This document was created to make public non-proprietary data contained in Special Conditions, Equivalent Safety Findings and Deviations that are part of the applicable Certification Basis as recorded in TCDS EASA.IM.A.071

190/D-29 (DEV): Emergency Exit Marking	
APPLICABILITY:	ERJ 190-100ECJ
REQUIREMENTS:	JAR 25.812(b)(1), 25.811(d)(1)(2)(3)
ADVISORY MATERIAL:	AMC 25.812(b)(1) of CS-25 Amdt. 3

FIGURE 1 – EXIT SIGN OVER THE TYPE III OVERWING DOOR

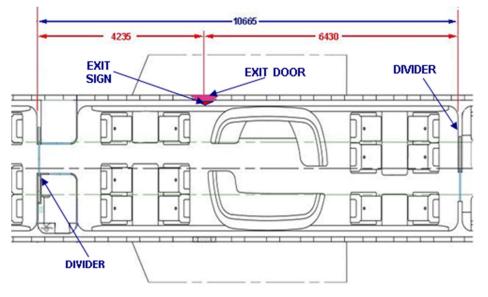
a) One combined sign to be installed above the Type III exit opening to serve as the exit locator sign and exit marker sign required by 25.811(d)(1) and (2) respectively.

As shown in FIGURE 1 below, the prism shape exit sign, functioning as exit locator and exit marker (thus complying with 25.811(d)(1) and 25.811(d)(2)), is to be installed in the lounge area located in the mid compartment, which is between two dividers. Its shape will allow legibility by occupants approaching along the aisle from forward and aft of the sign, and also from inboard of the sign.

In the guidance material AMC 25.812(b)(1) published by EASA together with CS-25 Amdt. 3 a relation between viewing distance and size of symbolic exit signs is provided. EASA will accept smaller exit signs with a letter height of not less than 1", provided that:

The maximum viewing distance of a person seated in any seat certified for TTO&L is not exceeding the distance calculated by the formula given in the AMC material.

FIGURE 2: EXIT LOCATOR INSTALLED ON FWD BULKHEAD

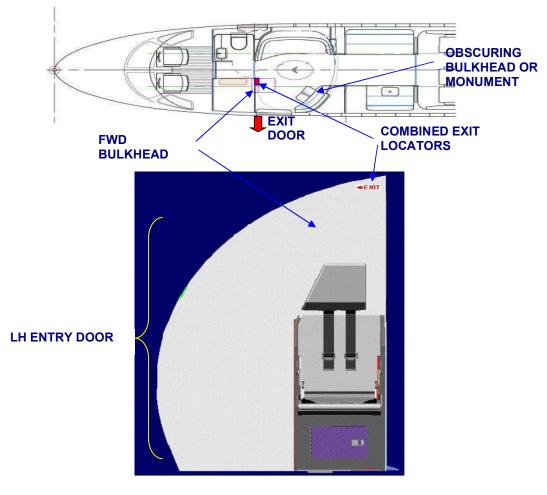
b) One combined sign to be installed on the aft face of the forward bulkhead, over the flight attendant seat to indicate the position of the Type I LH entry door, to use a combined exit locator sign to comply with 25.811(d)(1) and 25.811(d)(3).

The exit locator sign [required by 25.811(d)(1)], which is at the same fuselage station as the exit, also provides a clear indication of the exit location to the egressing passenger. The forward exit and the location of the exit locator sign are close to the obscuring bulkhead or monument.
